HISTORIC AND DESIGN REVIEW COMMISSION

November 03, 2021

HDRC CASE NO: 2021-541
ADDRESS: 210 LAVACA ST
LEGAL DESCRIPTION: NCB 713 BLK 10 LOT 11
ZONING: RM-4
CITY COUNCIL DIST.: 1
DISTRICT: Lavaca Historic District
APPLICANT: Vicki Yuan/Lake Flato Architects
OWNER: HILL STACEY L
TYPE OF WORK: Carport trellis installation and fenestration modifications
APPLICATION RECEIVED: October 15, 2021
60-DAY REVIEW: Not applicable due to City Council Emergency Orders
CASE MANAGER: Katie Totman

210 Lavaca Street
Supporting Documentation for Certificate of Appropriateness Request
10.15.2021
Lake|Flato Architects, contact Vicki Yuan at vyuan@lakeflato.com

Refugio Street Elevation
Scale: 1/16" = 1'-0"

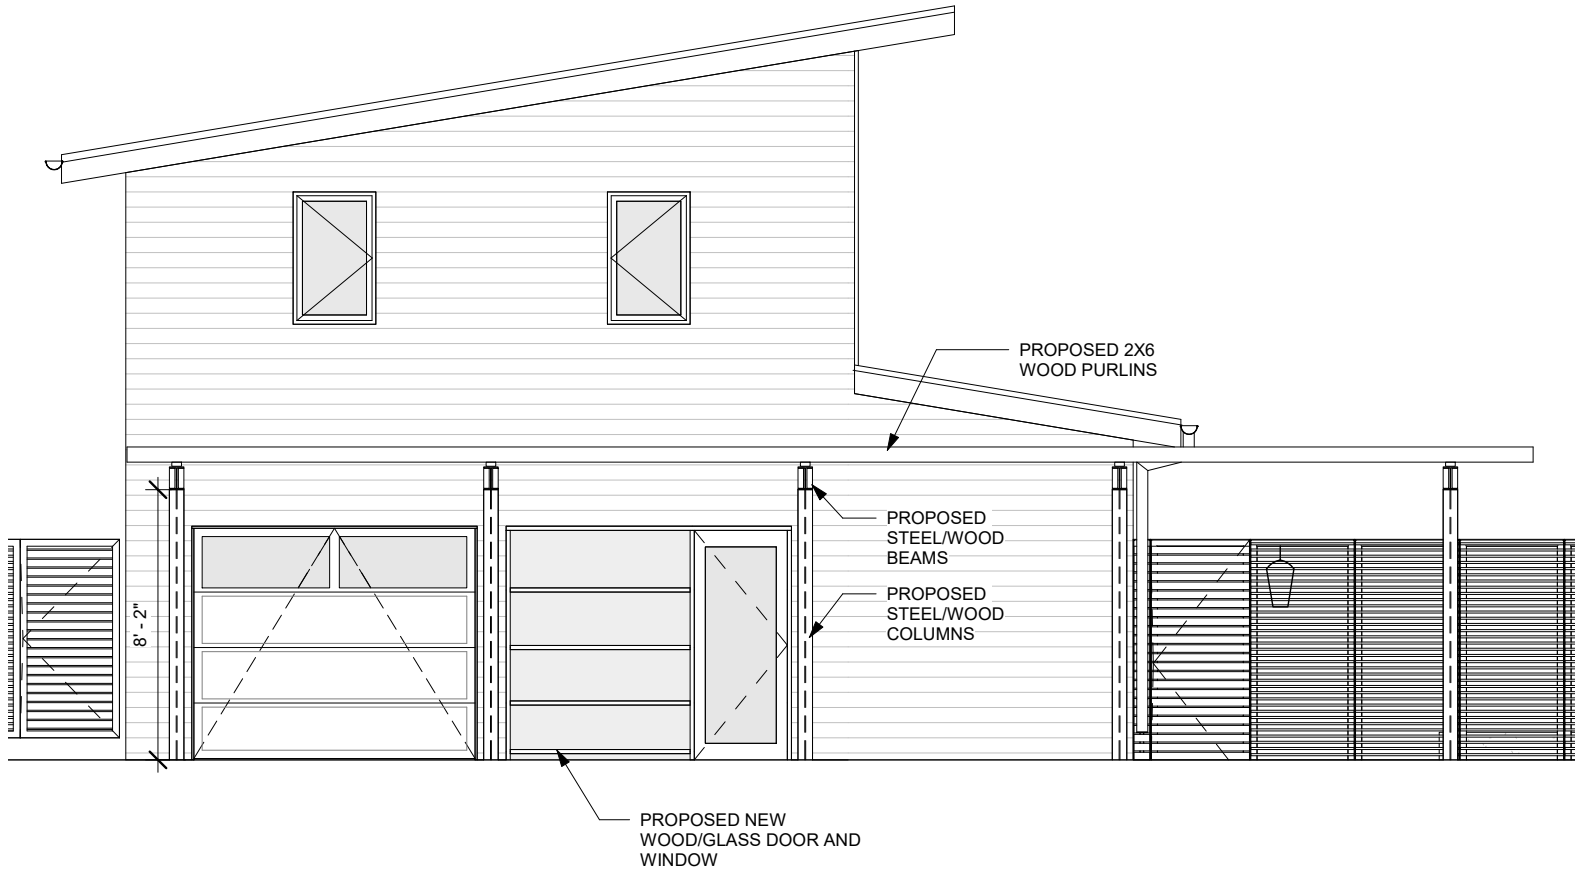
- b. TRELLIS INSTALLATION – The applicant is proposing to add a steel and wood trellis that will extend approximately 6-feet away from the edge of the building and cover the driveway. It will also feature a 3-foot setback from the property line. The existing conditions in the immediate vicinity of this area of Refugio Street is comprised of properties where rear yards back up to the street, with a few primary structures fronting Refugio Street. Staff finds that the trellis and its location is appropriate.

- c. EXTERIOR ALTERATIONS – The applicant is proposing to replace one (1) existing garage door with a wood and glass pedestrian entry door and one (1) window. According to the Guidelines for Exterior Maintenance and Alterations. 6. B. ii., new entrances should be compatible in size, scale, shape, proportion, material, and massing with historic entrances. The proposed pedestrian door appears to be generally consistent to the other doors on the structure. Staff finds this modification to be consistent with the Guidelines.

Staff recommends approval as submitted based on findings a through c.
